ELECRAFT Application Note K3 Synthesizer ALC

Revision A, December 23, 2008 Copyright © 2008, Elecraft, Inc., All Rights Reserved

Figure 3. Modifying the KSYN3 Board.

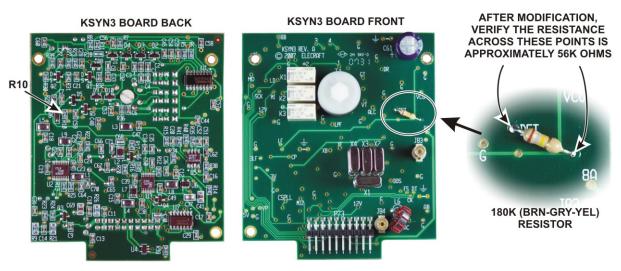
Reducing the value of resistor R10 from 82 K to 56 K establishes a higher minimum VCO current. This keeps the VCO output above 1.0 V pp even at very high operating temperatures (tested to > 50 C). The result is that the PLL never loses lock.

This modification requires some simple soldering to install a resistor on the KSYN3 board. You may install a conventional leaded 180 K resistor in parallel with the existing SMD resistor R10 or, if you have the tools, you may replace the SMD resistor with a 56K unit. A leaded 180 K resistor can be provided by Elecraft.

Modify each KSYN3 board as shown in Figure 3. Install the 180 K (first three colors: brn-gry-yel) leaded resistor on the front of the board as shown. This places the resistor in parallel with the existing 82 K R10. You can solder from the top of the board to avoid the possibility of creating an unwanted solder bridge. Confirm that you have properly completed the modification by checking the resistance as shown. The actual resistance reading you see may vary according to the tolerance of the resistors and your DMM.
